Office Action Summary

10/663,723

SHIRAKI, YASUHIRO

FIG. 8

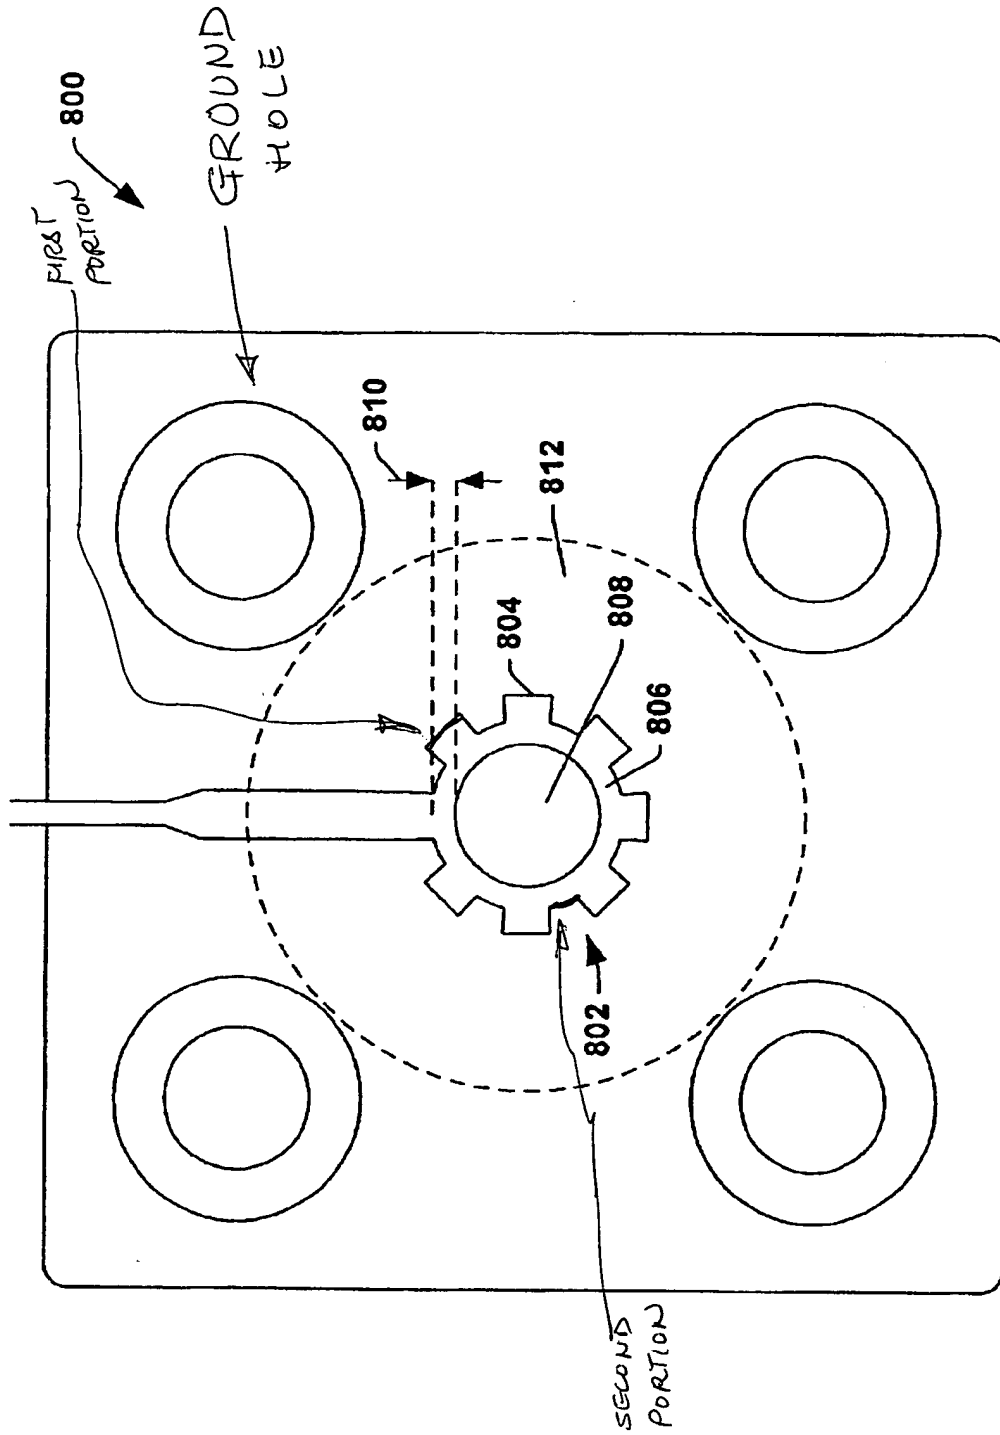
each signal layer including a signal line (signal line as shown in figure 8, shown as element 276 in figure 2), a through-hole (404) electrically interconnecting the signal lines of said plurality of signal layers, and a ground through-hole (408) electrically interconnecting one of a plurality of ground layers (416) and a plurality of power supply layers of said multi-layer printed board, wherein said signal layer includes a land (land connected with the signal trace as shown in figure 8) connecting said through-hole to said signal line; said land has an external periphery with a first portion (portion with a periphery of projection 804, as marked on figure 8, in appendix "A") and extending further from a center of the land than any other portion of the external periphery and a second portion (second portion as marked on figure 8 in appendix "A") having a second radius (radius of disc portion 806) and extending a shorter distance from the center of the land than said first portion and a portion of the external periphery of said land opposite the ground through-hole (ground hole as marked on figure 8 in appendix "A") closest to the center of said land is the second portion (second portion as marked on figure 8 in appendix "A").
